TECHNICAL INFORMATION

Rear Brake Pad Identification Markings Improved

No: 70/03/06/NAS
FGN: 206 – Brake Systems
Ref:
Issue: 1
Date: 13 November 2006

Range Rover (LP)	All (1995-2002 MY)
Discovery Series II (LT)	All (1999-2004 MY)

Figure 1

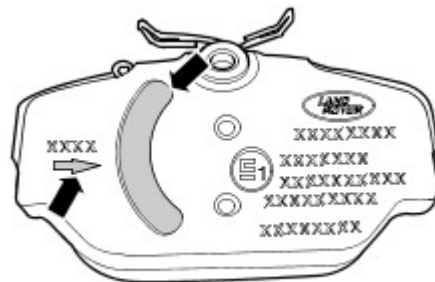
Identification markings on the rear of the brake pads have been improved to make rear brake pad identification and placement easier.

Current markings on the rear of the pads made it difficult to identify which pad is left-hand/right-hand or which pad is the inner/outer.

**NOTE:** The rear inner brake pads can be identified by a crescent shaped cut-out in the anti-rattle shim on the back side of the pad. (Upper black arrow in Figure 1)

The white direction arrow marked on the back side of the inner pads indicates the direction of the brake disc rotation when the pad is installed. (Lower black arrow in Figure 1)

1. Identify the rear **inner** brake pads by the crescent shaped cut-out and white direction arrow located on the back side of the pads. (Arrowed in Figure 1)
2. Identify the rear **outer** brake pads without the crescent shaped cut-out or direction arrow identification.
3. When installing the **inner** brake pads, ensure the following:
 - The direction arrow points in the direction of brake disc rotation.
 - The crescent shaped cut-out is positioned at the **BOTTOM**.
